**CITY OF LA VISTA
MAYOR AND CITY COUNCIL REPORT
AUGUST 1, 2023 AGENDA**

Subject:	Type:	Submitted By:
CONDITIONAL USE PERMIT – LOT 1 SOUTHPORT EAST REPLAT FIFTEEN	◆ RESOLUTION ORDINANCE RECEIVE/FILE	CHRISTOPHER SOLBERG DEPUTY COMMUNITY DEVELOPMENT DIRECTOR

**CITY OF LA VISTA
PLANNING DIVISION
RECOMMENDATION REPORT**

RE: REV Development – PUD, CUP & Replat Applications – Initial Review Letter
Lots 5-6 Southport East

LANDSCAPE PLAN
LOT 1 CUP SUBMITTAL
SOUTHPORT EAST
PORT GRACE BLVD & S. 123RD PLAZA

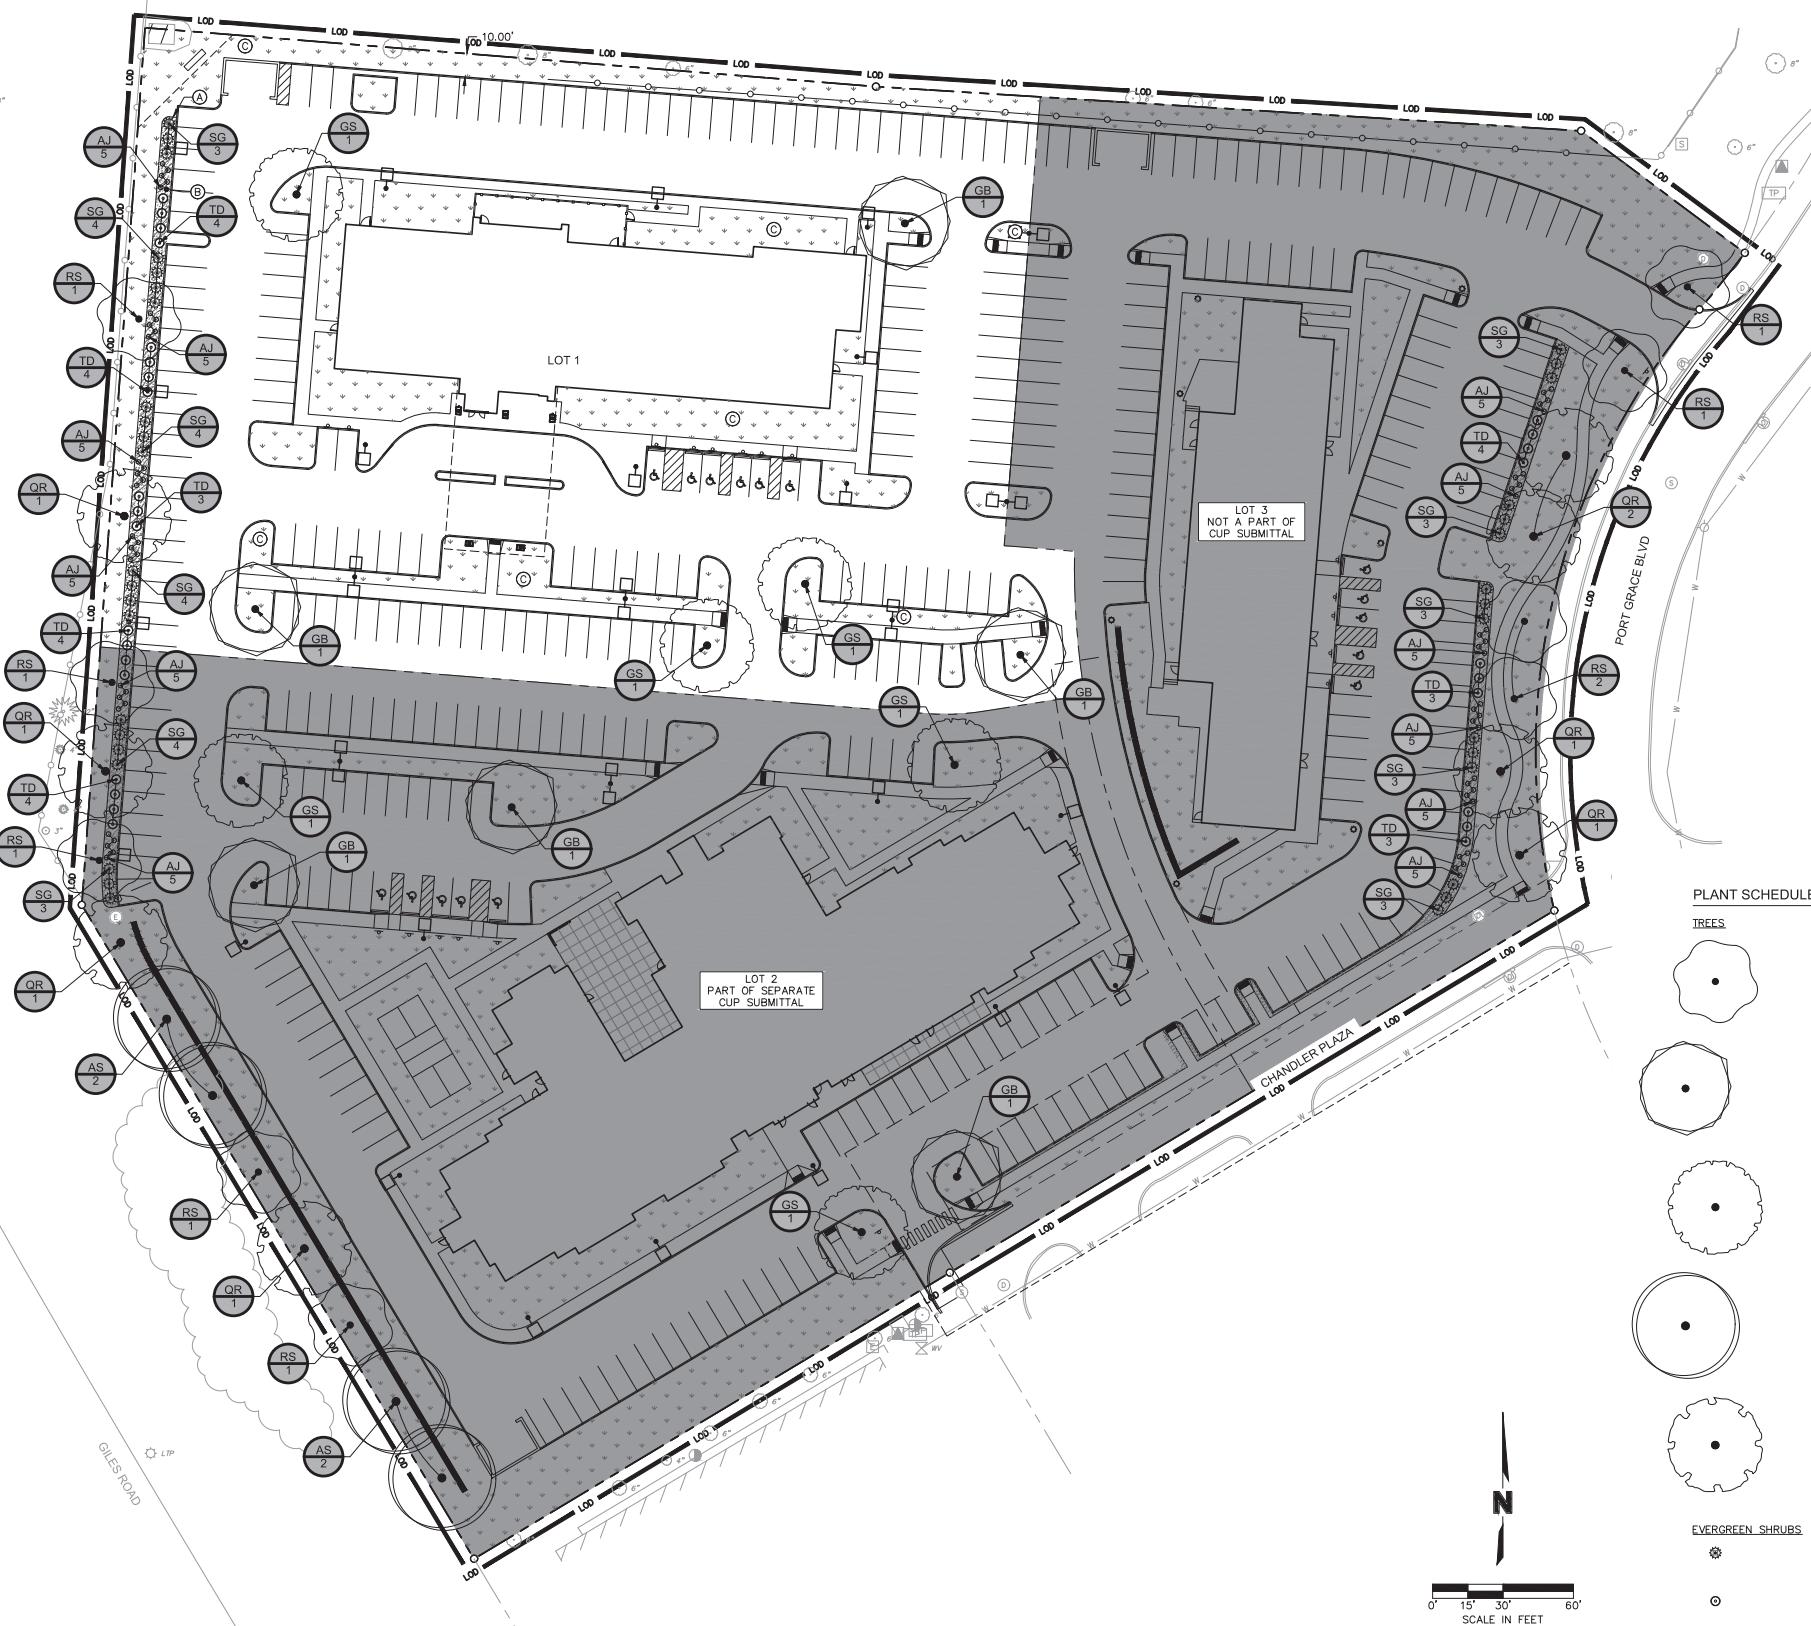
1. Landscaping
 - i. No site dimensions are included to determine compliance with 6.1.D, which requires ten (10) foot wide landscaped, turfed (sodded or seeded) and irrigated green space along all interior lot lines shown in Appendix E.
 - ii. Per appendix G, the following proposed plants are not included in the approved list:
 1. Autumn Blaze Maple
 2. Bloodgood London Plane Tree
 3. Silver Linden
 4. Maney Juniper
 5. Karl Foerster Feather Reed GrassRevise to comply with Appendix G.
 - iii. Per Appendix G, trees shall have a minimum caliper of 3". Trees proposed on plant schedule have a caliper ranging from 2 to 2.5". Revise to comply with Appendix G.
